SERVICE BULLETIN No. L 13/001

Subject: L 13 sailplanes P/N 170101 through 170105, 170107, 170108, 170201, 170203 through 170206, 170208, 170209, 170211 through 170216.

Subject: Increase of clearance between the edge of aileron end rib and control rod at the maximum deflection of aileron upwards.

Detail A

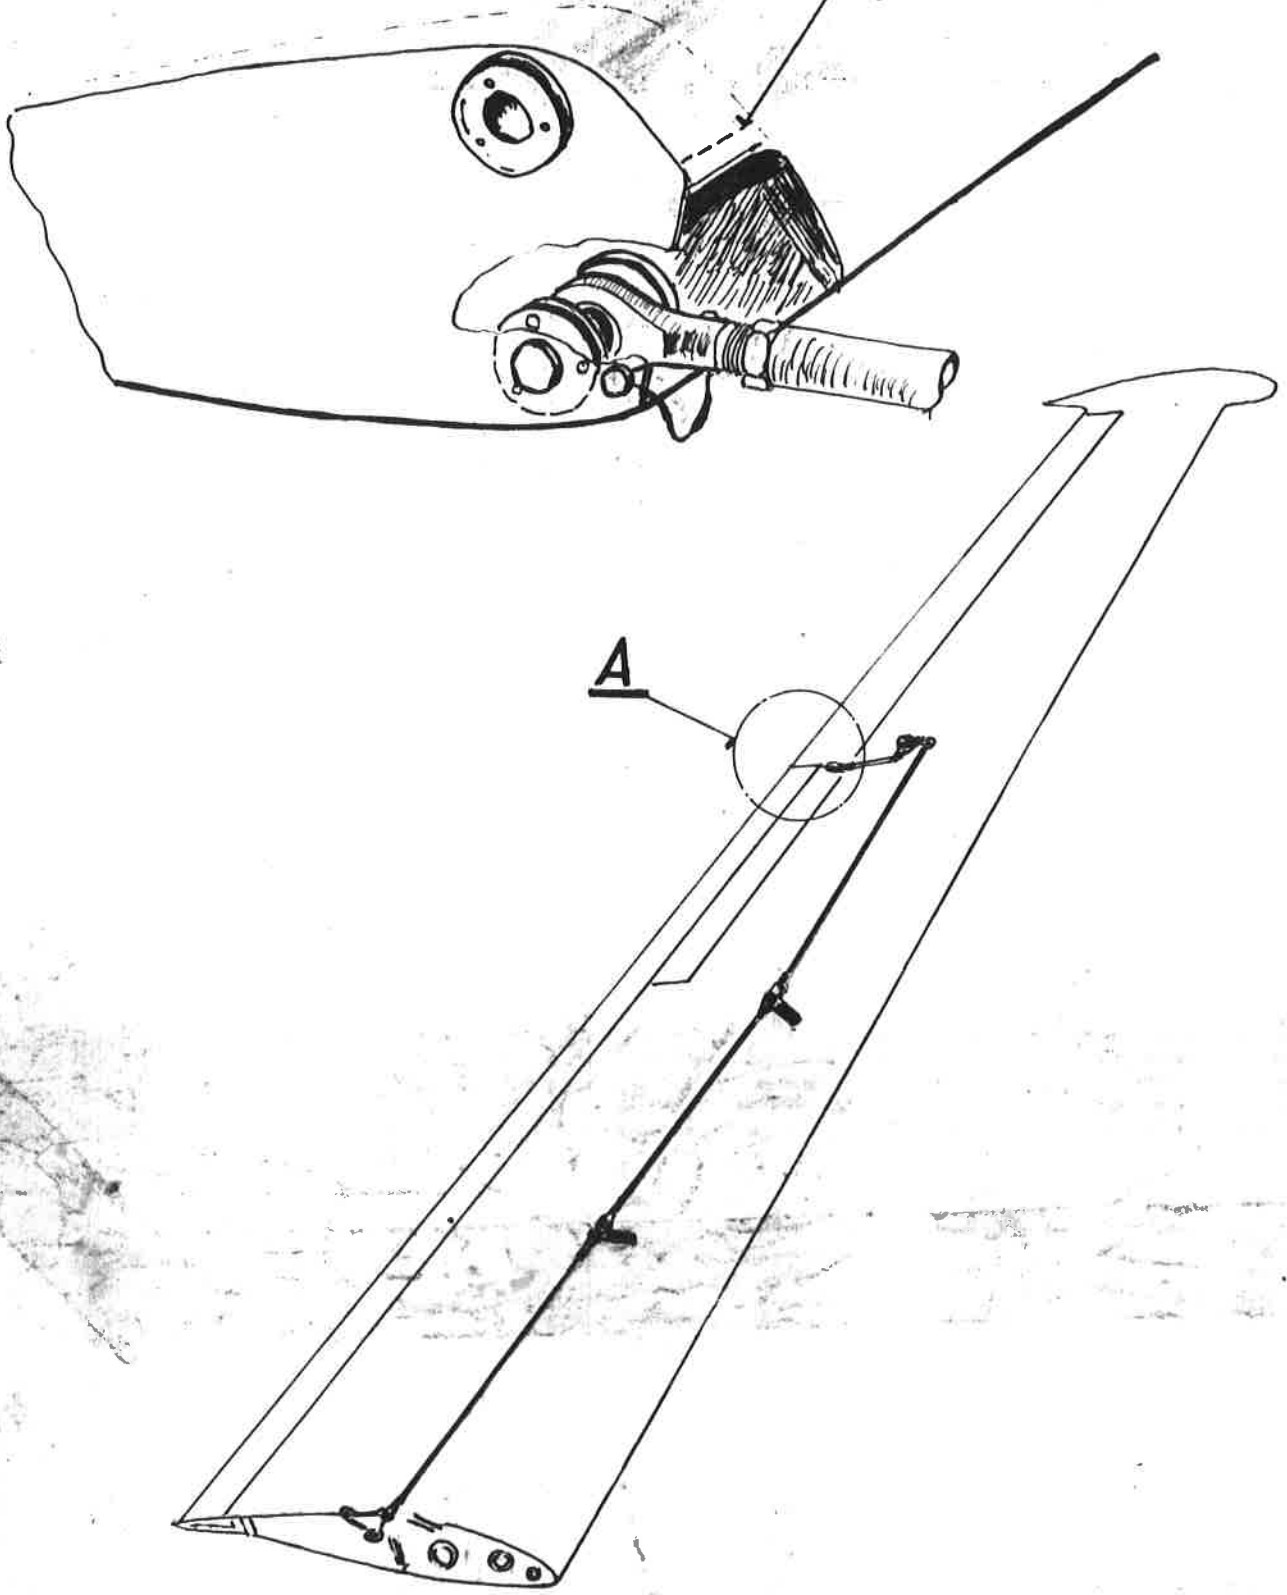
Description: At finished and delivered aircraft check for minimum proper clearance of 3mm between the control rod and edge of end rib at maximum /hand/ deflected aileron upwards. No modification is required when the clearance is correct.

Where this clearance is not sufficient, remove the control rod and file off detail A from the rib No.19 so as to obtain a clearance of 3 mm when maximum deflected.
